SODA SPRINGS JT. SCHOOL DISTRICT #150

Re: Change Order Options

Tigert Middle School
HCC Job # 201707

Project Name & No.: Tigert Middle School Additions &
Renovations - 1715

ROOF STEP DETAIL

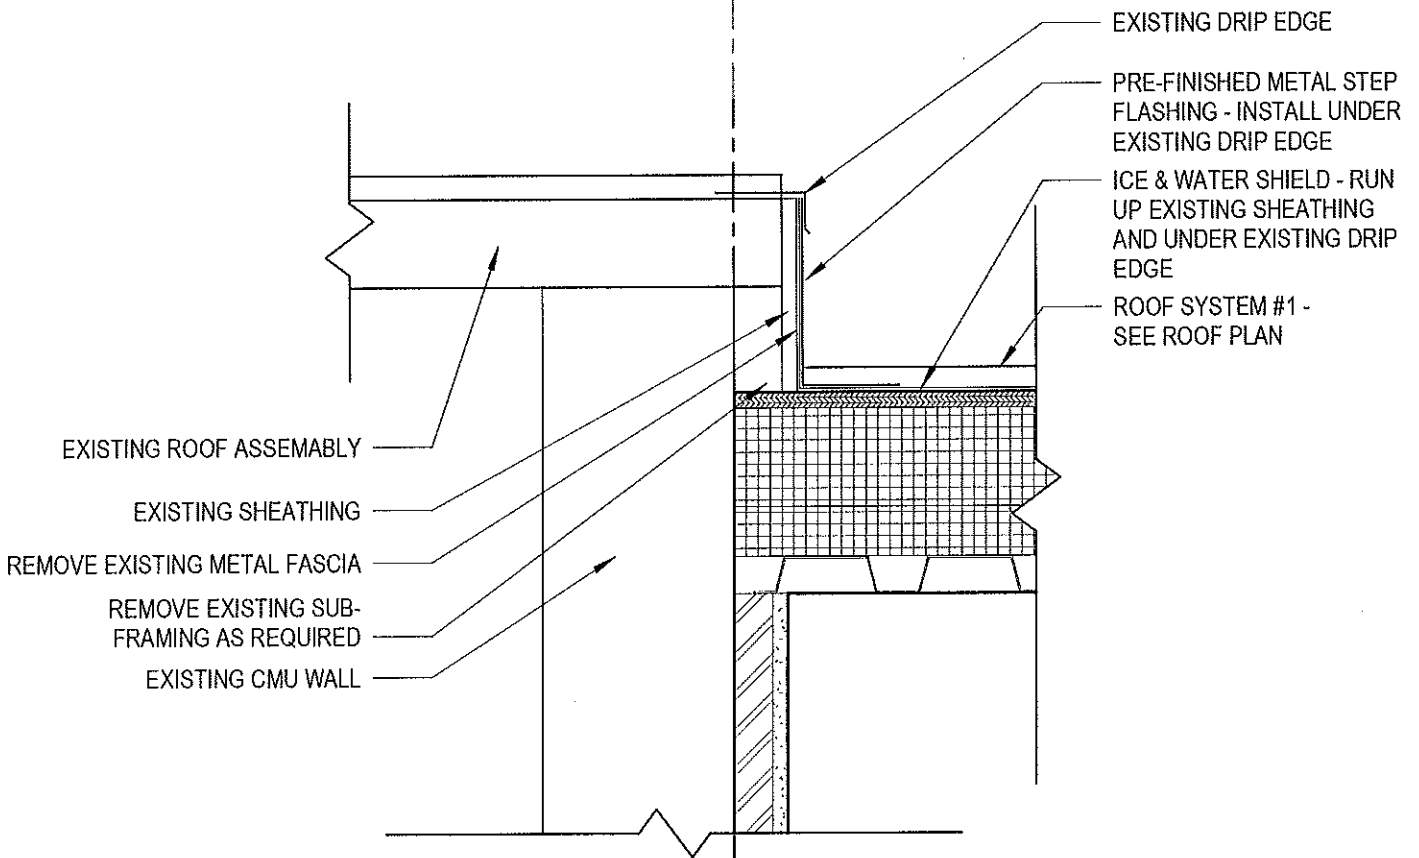
Provide the following changes to the Classroom Addition roof on Sheet A4.1 & A4.2 as follows:

1. Revise "This existing gable to be re-shingled with construction of classroom wing roof" to "No work will be required to this existing gable with the construction of the classroom wing roof".
2. Add Detail Bubble 8/A4.2 at edge of existing roof and new roof.
3. Add Detail 8/A4.2 Roof Step Detail.
